# UNITED STATES PATENT AND TRADEMARK OFFICE

APPLICATION NO.	FILING DATE	FIRST NAMED INVENTOR	ATTORNEY DOCKET NO.	CONFIRMATION NO.		
10/567,195	10/03/2006	Christopher Lyndon Higgins	ABAC0101PUSA	9579		
22045	7590	03/30/2009	EXAMINER			
BROOKS KUSHMAN P.C. 1000 TOWN CENTER TWENTY-SECOND FLOOR SOUTHFIELD, MI 48075				KIRSCH, ANDREW THOMAS		
ART UNIT		PAPER NUMBER				
3781						
MAIL DATE		DELIVERY MODE				
03/30/2009		PAPER

<b>Office Action Summary</b>	<b>Application No.</b>	<b>Applicant(s)</b>
	10/567,195	HIGGINS, CHRISTOPHER LYNDON
<b>Examiner</b>	<b>Art Unit</b>	
ANDREW T. KIRSCH	3781

## **DETAILED ACTION**

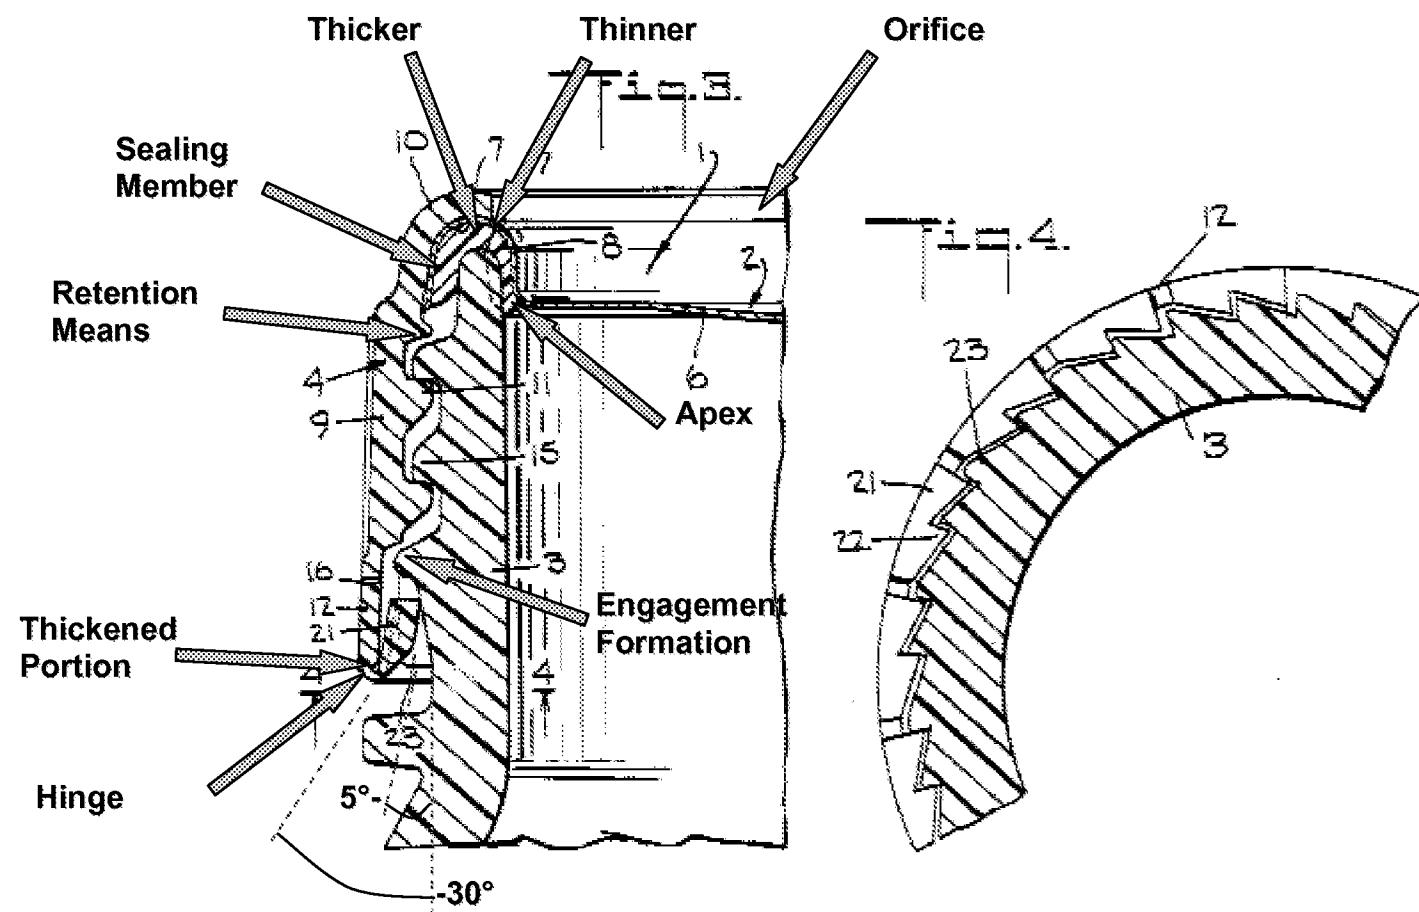
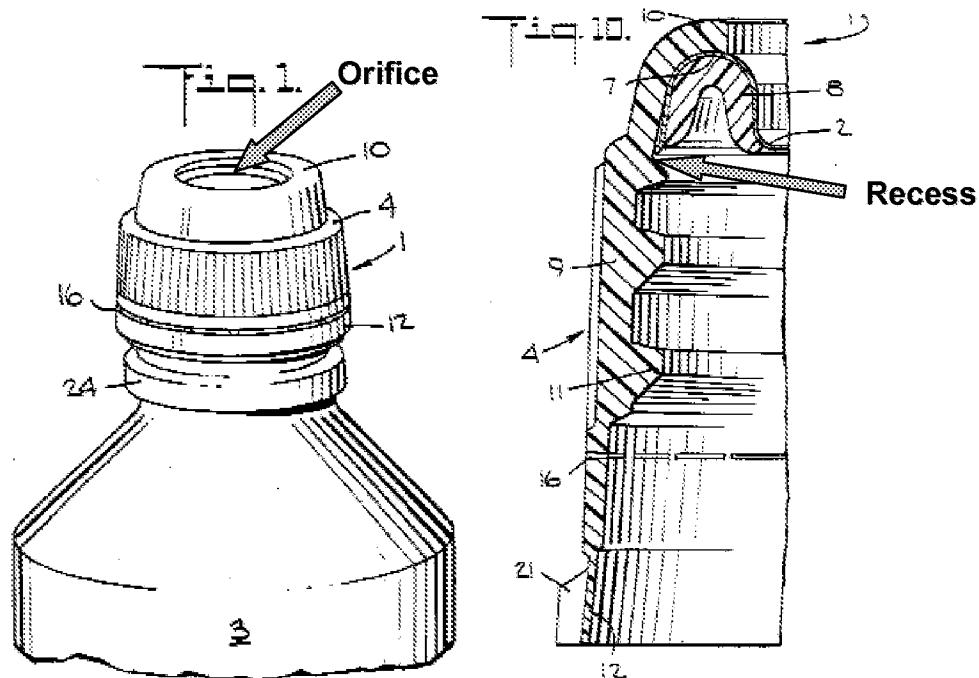
10. In re claim 1, with reference to Figs. 3 and 4 below, Ochs discloses: A container (3) and a closure (1) for connection to said container, said closure including: an upper wall (10); a skirt (9) formed integrally with and extending downwardly from said upper wall, said skirt including a helically threaded section (11) on an internal face (4); a tamper-evident band (12) frangibly connected to said skirt, said tamper-evident band including an annular wall (12) from which extends a series of discretely spaced tabs (21) adapted such that when said closure is fully applied to said container said tabs face inwardly and upwardly; said container including: a neck with a helically threaded section (15) formed on an external surface and adapted to engage with said helically threaded section (11) on the internal face of the skirt of the closure so as to secure the closure to the container; a tamper-evident band engagement formation (see Fig. 3) located on said neck beneath said helically threaded section, said engagement formation including a downwardly and outwardly extending upper face to facilitate passage of said tabs over the engagement formation and reduce force on the tamper-evident band during application of the closure to the container, and three or more discretely located

engagement surfaces (23) in at least one quadrant of said neck for engagement with said tabs on said tamper-evident band; such that upon rotation of said closure to remove, said closure from said container said tabs engage with said engagement surfaces to resist rotation of said tamper evident band and facilitate breaking of the band from the skirt of the closure (column 3, lines 27-30).

11. In re claim 2, with reference to the Figs. above, Ochs discloses the claimed invention including wherein said engagement surfaces (23) are adapted upon removal rotation of the closure to simultaneously engage with said tabs (21) (column 3, lines 27-30).

12. In re claim 3, with reference to the Figs. above, Ochs discloses the claimed invention including wherein said tabs (21) cooperate with projections (23) on said container neck such that when said closure is fully applied said tabs are located between the neck projections (23) and lie against the neck of the container (as shown in Fig. 3).

13. In re claim 4, with reference to the Figs. above, Ochs discloses the claimed invention including wherein said helically threaded sections on the neck (15) and/or closure (11) are segmented (the threads of Ochs all have a top segment, a vertical inner segment, and a bottom segment, wherein the segments are surfaces).

14. In re claim 5, with reference to the Figs. above, Ochs discloses the claimed invention including wherein said closure further includes an annular sealing member (8) depending from said upper wall (10), said sealing member adapted to seal against the neck (17) of the container.

15. In re claim 6, with reference to the Figs. above, Ochs discloses the claimed invention including wherein said annular sealing member (8) seals against an inner wall of the neck of the container.

16. In re claim 7, with reference to the Figs. above, Ochs discloses the claimed invention including wherein said annular sealing member (8) includes a circumferentially extending apex (see Fig. 3) adapted to seat against said inner wall of the neck (17) portion of the container (3).

17. In re claim 8, with reference to the Figs. above, Ochs discloses the claimed invention including wherein the said closure includes a sealing member (see Fig. 3) adapted to seal against an outer surface of the neck (17).

18. In re claim 9, with reference to the Figs. above, Ochs discloses the claimed invention including wherein said tamper-evident band (12) is connected to a lower surface of said skirt by a frangible section (16) formed by a series of circumferentially spaced ribs separated by slots (as seen in Figs. 1 and 10 below).

20. In re claim 11, with reference to the Figs. above, Ochs discloses the claimed invention including wherein said tabs (21) are connected to the lower surface of the annular wall (12) by means of a hinged section (see Fig. 3).

21. In re claim 12, with reference to the Figs. above, Ochs discloses the claimed invention including wherein said tamper-evident band includes a thickened section (see Fig. 3) at the hinge point such that when the closure (1) is fully applied to the container the angle between the tab (21) and the neck of the container is approximately five degrees or less (see angle noted in Fig. 3).

22. In re claim 17, with reference to the Figs. above, Ochs discloses the claimed invention including wherein said neck of the container further includes an annular bead (see Fig. 3) located below said threaded section (15) and extending radially outwardly from said external surface of the neck.

23. In re claim 18, with reference to the Figs. above, Ochs discloses the claimed invention including wherein said ramped projections (23) extend downwardly from said bead.

tabs (21) and the tamper evident band (12) is in the range of 0 to 50 degrees (see Fig. 3).

26. In re claim 21, with reference to the Figs. above, Ochs discloses the claimed invention including wherein said closure is moulded such that the angle between the tabs (21) and the tamper evident band (12) is in the range of 0 to 45 degrees (see Fig. 3).

27. In re claim 22, with reference to the Figs. above, Ochs discloses the claimed invention including wherein said closure is moulded such that the angle between the tabs (21) and the tamper evident band (12) is approximately 30 degrees (see Fig. 3).

30. In re claim 26, with reference to the Figs. above, Ochs discloses the claimed invention including wherein walls of the receptacle are tapered (at 8) such that the walls are thicker at the point where the receptacle joins the upper wall (10) of the closure and are thinner at the open end of the receptacle (see Fig. 3).

31. In re claim 27, with reference to the Figs. above, Ochs discloses the claimed invention including wherein said closure includes a retention means (see Fig. 3)

33. In re claim 29, with reference to the Figs. above, Ochs discloses the claimed invention including wherein said retention means takes the form of an annular flange (see Fig. 10) depending from said inner surface of said upper wall (10).

34. In re claim 30, with reference to the Figs. above, Ochs discloses the claimed invention including wherein said retention means takes the form of one [or more] recess (see Fig. 10) formed in said inner surface of said upper wall (10).

FIG.1

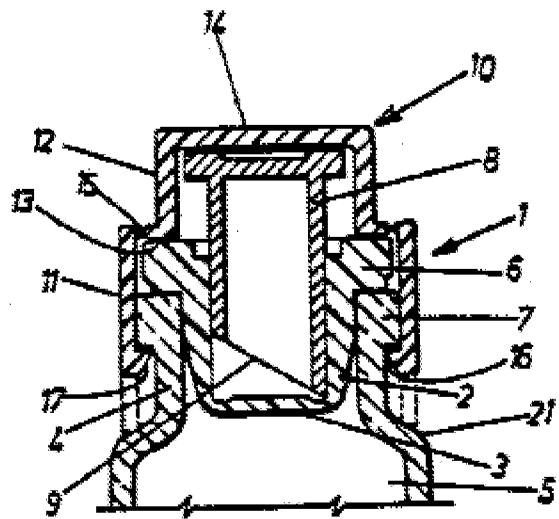
46. However, with regards to the “means for dispensing one or more additives into the container,” this limitation meets the three-prong test per MPEP 2181 and thereby invokes 35 USC 112 6th paragraph. In the instant specification, pages 13-14, lines 31-26, the “means for dispensing” is shown in Fig. 1 of Rizzardi below, which discloses a container closure with a frangible tamper evidence band and means for dispensing an additive into the container including a plunger (8), a breakable bottom (3), which together create a sealed reservoir (2) (Col. 2, lines 30-42). The dispensing means in Rizzardi are considered to be an equivalent to applicant’s means for dispensing because they perform the same function in substantially the same way and produce substantially the same result as the corresponding element in applicant’s specification.

47. Therefore, it would have been obvious to one of ordinary skill in the art at the time the invention was made to have combined the dispensing means of Rizzardi with the container closure of Ochs for the purposes of dispensing a substance from an internal reservoir into the container as taught by Rizzardi.

48. In re claim 14, with reference to the Figs. above, Ochs in view of Rizzardi disclose the claimed invention including wherein said dispensing means (2, 3, 8) depends from said upper wall (14) of said closure.

49. In re claim 15, with reference to the Figs. above, Ochs in view of Rizzardi disclose the claimed invention including wherein dispensing means (2, 3, 8) includes a sealed housing (2, 8) within which said one or more additives are contained.

50. In re claim 16, with reference to the Figs. above, Ochs in view of Rizzardi disclose the claimed invention including wherein dispensing means includes a plunger

(8) located within said housing for ejection of said one or more additives from said sealed housing into the container.
